ALLAMAKEE CSD MIDDLE SCHOOL HVAC UPGRADE
WAUKON, IOWA

ADDENDUM 01
March 2, 2026

LIGHTING PLAN - AREA A

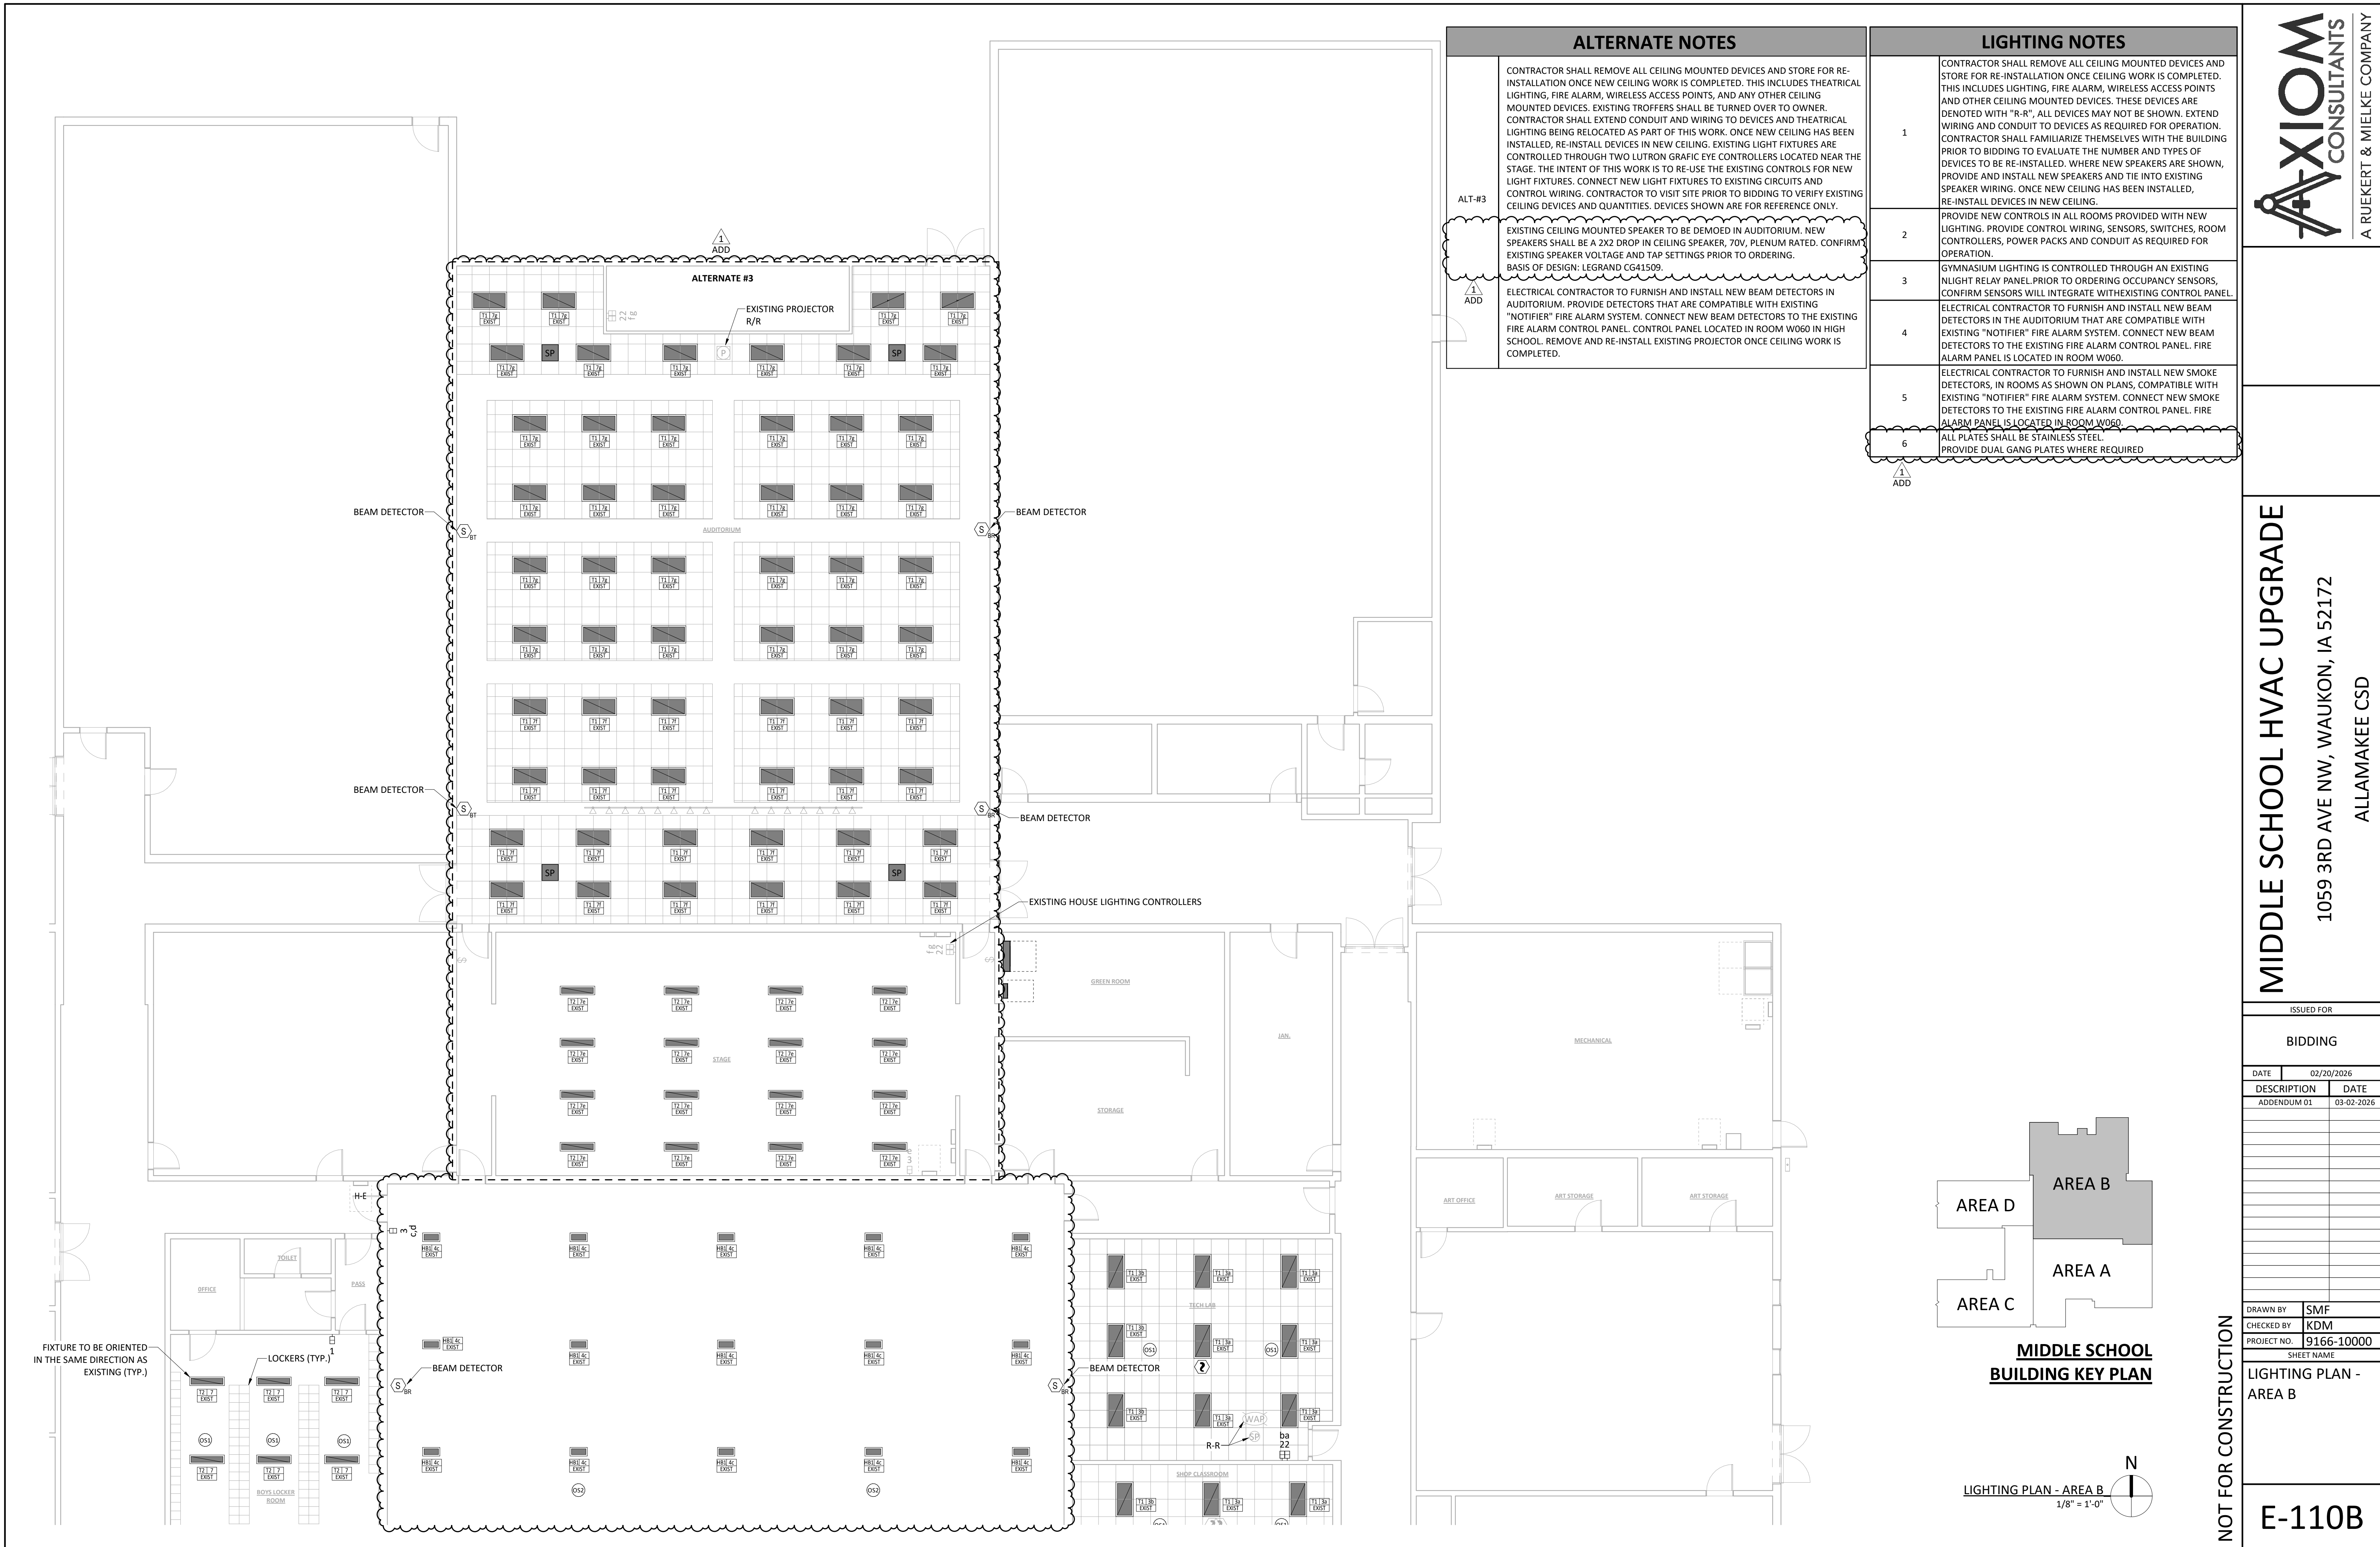
1. Added proposed lighting fixtures, smoke detectors, occupancy sensors, light switches, square ceiling mounted speakers, and room controllers in north Admin area and the janitor's closet near the kitchen.
2. Added proposed square ceiling-mounted speakers to south Admin area.
3. Added proposed lighting fixtures in janitor's closet near kitchen.
4. Revised light switch type and zoning control in the gymnasium.
